# NABCO ENTRANCES INC.

## Service Bulletin Index

## NABCO ENTRANCES TECHNICAL BULLETIN

### 1175 Full Open Bottom Guide Change

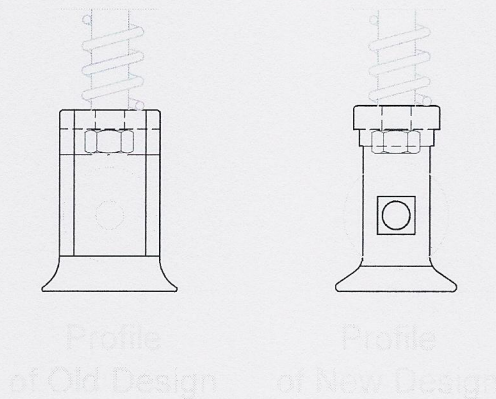
To eliminate interference between the housing casting of the bottom guide and the "T" nut of the tie rod assembly inside the bottom rail of the full open door, the casting supporting the shoulder bolt has been changed. This redesign will negate the rubbing or stickiness in the door rotation when the door is panicked open.

The new casting was also designed to raise the nut holding the shoulder bolt farther from wheel. In some cases, a washer was needed between the shoulder bolt and the casting to prevent the end of the bolt from rubbing on the wheel. This will no longer be necessary with the new casting.

The new part is a direct replacement for the old part. Since they are installed in the factory, no additional work is required of the installed due to this change. It fits into the same track and the mounting holes on the stiles remain the same. The new parts are due from the casting company in mid to late May. They will be appearing in the 1175 Whisper Slide shortly after that.

## *Correction to 1175 Installation Manual* **Redesigned Floor Threshold for Sliders**

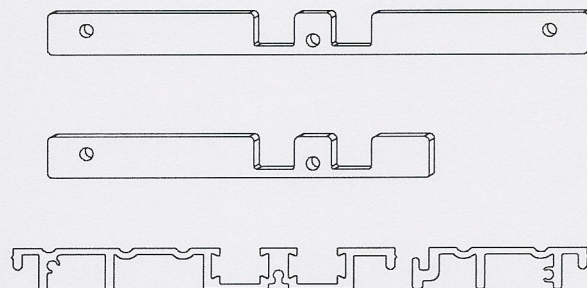
The extrusion for the threshold on full open and pocketed units has been redesigned to install in-line with the jamb tubes, *not offset as shown in Figure 8 of the manual*. Recessing the floor track has also been simplified with this change. A 1/2" deep by 4 1/2" wide (6 3/8" on pocketed units) channel across the entire opening is all that is required for recessing the unit. With this design change, the jamb tubes are recessed into the floor with the threshold. **Caution:** This type of installation must have been specified when the order was placed so that engineering could account for the recess.

With the modification to the extrusions, a screw spline was added to the threshold. In the near future, stainless steel caps & screws will be supplied in the parts box to seal off the exposed end of the threshold. If you would like to retrofit this installation, contact customer service to request the caps (part number 249857-10 for full open, 249857-20 for pocketed) and 3 screws (part number 240094-12). You need one set of the above parts for each exposed track.

Cross Section of New Ball Detent

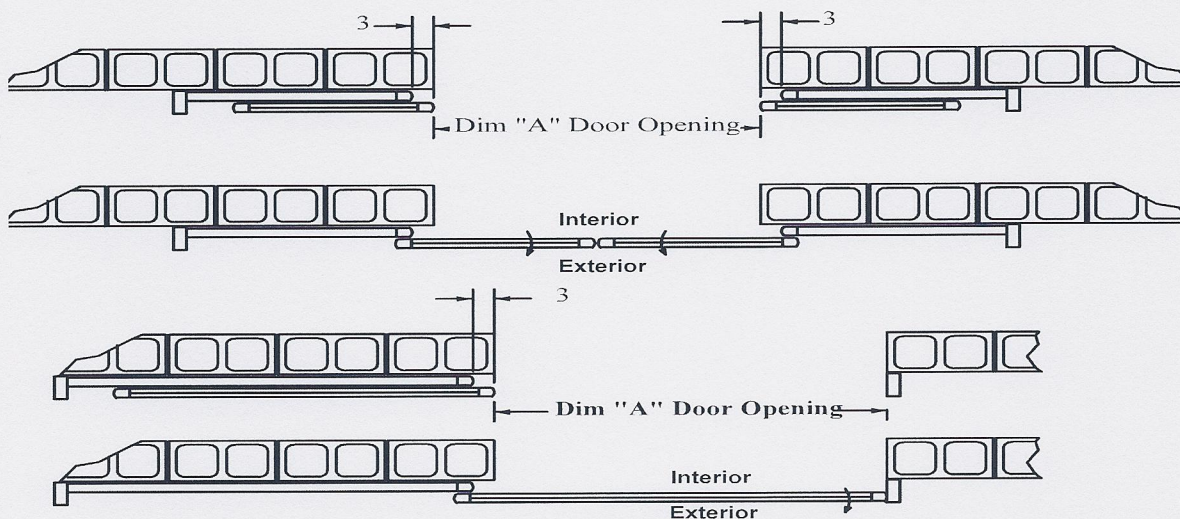
The size of the ball detents used on full open and pocketed units has been increased to provide a more secure fit into the header and the floor track. Because of the larger ball, the size of the hole used in step 17 on page 6 needs to be increased. It should read as follows:

The force provided by the ball detent is also adjustable with the new design. Remove the Ball Detent and Bracket assembly from the bottom or top of the stile. With a blade screwdriver, tighten or loosen the brass cap on the rear of the ball detent. Reinstall the Ball Detent and Bracket Assembly into the stile. Test and repeat if necessary.

The new Ball Detent was designed so that the part could replace the Ball Detents in Horton units and the hole pattern in the mounting bracket will allow the assembly to replace Stanley Ball Detent assemblies.

17. Locate the point where the score marks intersect the first centering groove on the bottom of the header (closest to the outside of the header) and the only groove on the floor track. Start with a 1/4" diameter drill, drill a hole at each location and countersink it to 3/8" x 82°. Increase the hole and countersink size until a satisfactory fit is obtained. **Caution:** Do not overdrill the hole to an oversized hole.

### Grounding of the 1175

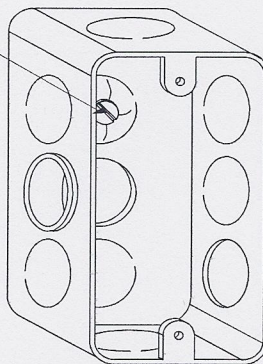
In order to provide a more sufficient method of grounding the 1175, a ground screw has been installed in the bottom of the switch junction box. This screw should be used for utility power grounding instead of header bolts specified in Section W, Step 2 of the Installation Manual.

## Night Mode on 1175 Rocker Switches

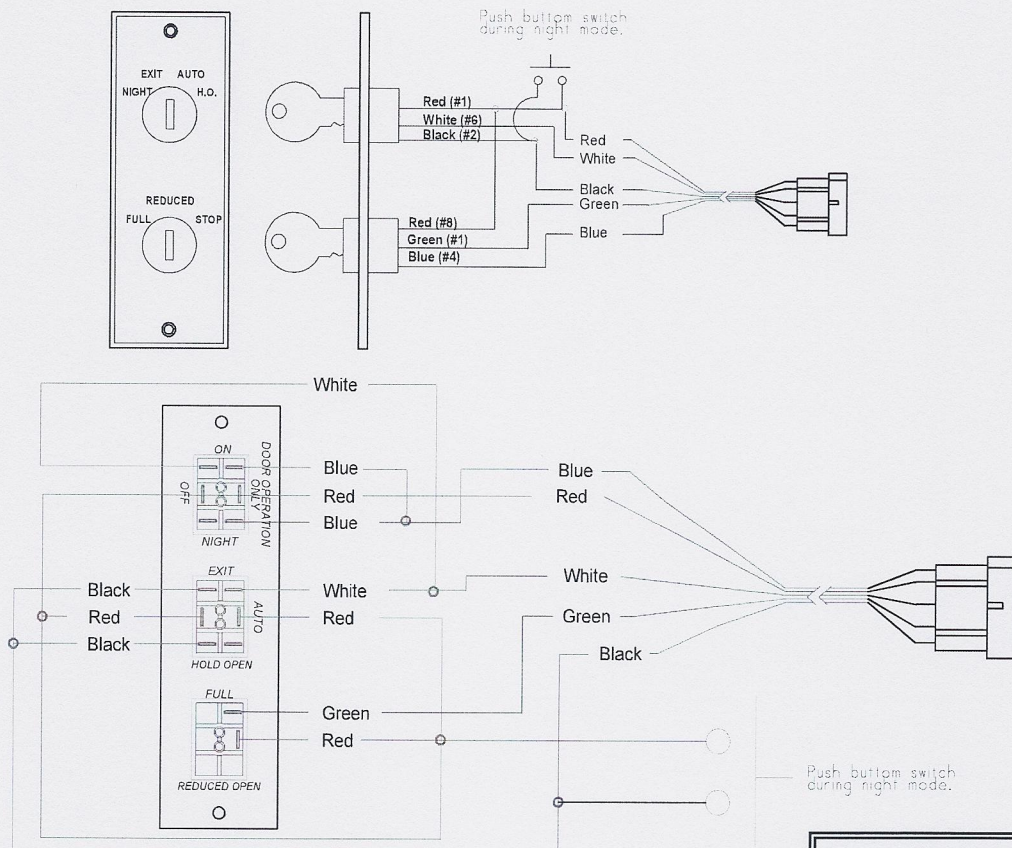
A fourth position has been added to the bank of control switches on the 1175 slider. The new position is labeled "Night" and is on both the rocker and the key switch assemblies. This new position is provided with all new slider switch assemblies and can be retrofitted with any U10 microprocessor based systems.

Night mode disconnects the activation signal from both the interior and the exterior Acusensors but still allows them to function as threshold protectors. Activation is achieved by either a wall push plate or card reader. To tie either of these devices into the system, the activation signal needs to be wired into the red and black wire of the switch assembly. Simple wiring diagrams are shown below.

### RIGHT HAND OUT SWING DOOR

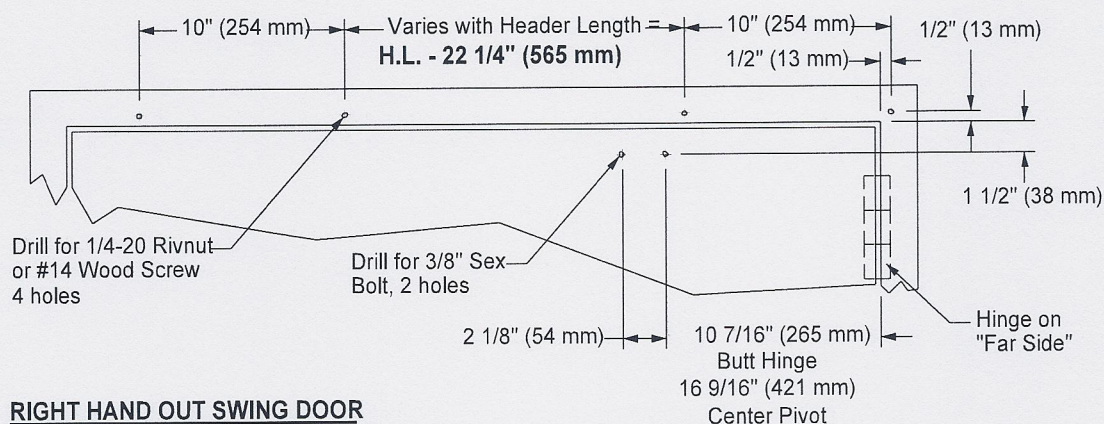
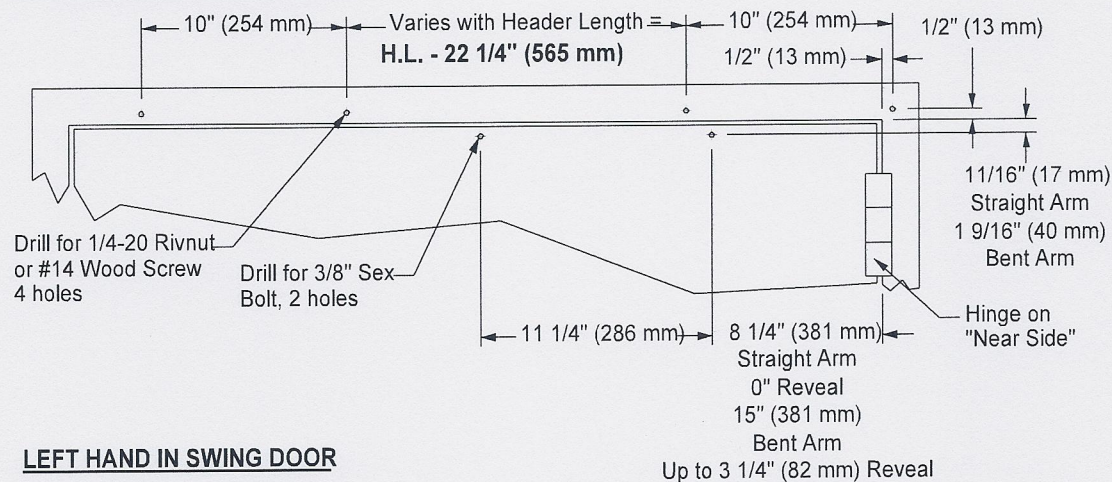
The Model 710 Header End Cap material thickness was revised in February 2001. The frame drilling details on page 6 of the Instruction Manual P/N 125660 should have been revised to reflect the material thickness change. Thus, locating frame screw holes to align with the header mounting screw holes. The appropriate 22-1/4 inch dimension is shown below.

## Mat Harness #22-0535-01 shipped between 3/15/02 & 7/25/02

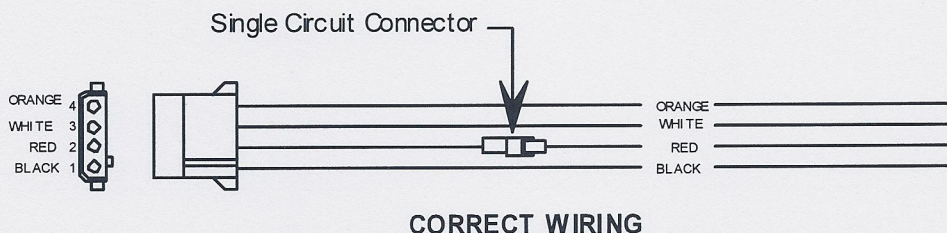
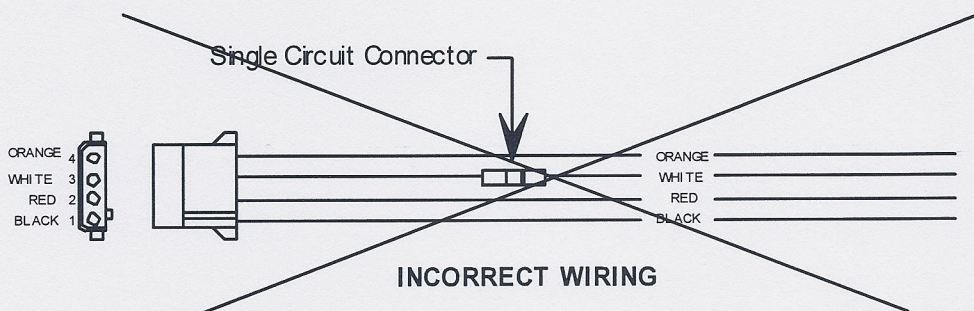
Mat harnesses shipped between 3/15/02 & 7/25/02 have the single circuit connector installed on the wrong color wire (white). Mat harnesses shipped after 7/25/02 are correct with the single circuit connector installed on the red wire. The only products affected using the single circuit connector are GT300, GT400 & GT500 inswing operators with the analog control (not U11 microprocessor) with a PANIC LATCH.

**DO NOT CONNECT THE PANIC LATCH TO THE WHITE WIRE!** The panic latch must be spliced into the RED wire for proper function of the door system. See correct harness at the bottom of this page.

### PART # 22-11350 - REVISED SWITCH TEXT AND WIRING

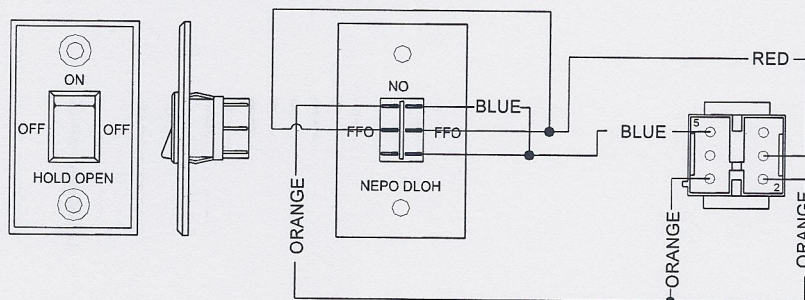
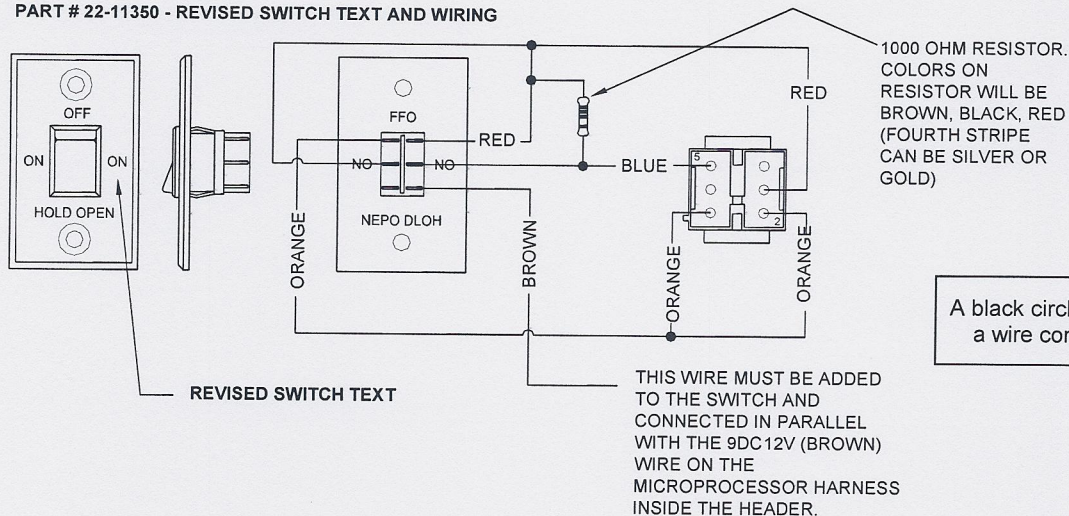
**Issue:** On current rocker switch configurations, if the rocker switch (P/N 12-9551) is set to HOLD OPEN while the door is open, the door will first fully close before going to HOLD OPEN.

**Solution:** To eliminate this, re-wire the rocker switch as shown below. The wording on rocker switch face plate will also need to be changed as shown below. Note: a new wire must be connected *in parallel* with the 9DC12V BROWN on the control's main harness (refer to tagged wires on control harness). This wire is routed to a pin on the rocker switch as shown. A 1000 ohm 1/4 watt resistor is also added as shown in the diagram. We will be making this change to current production models soon.
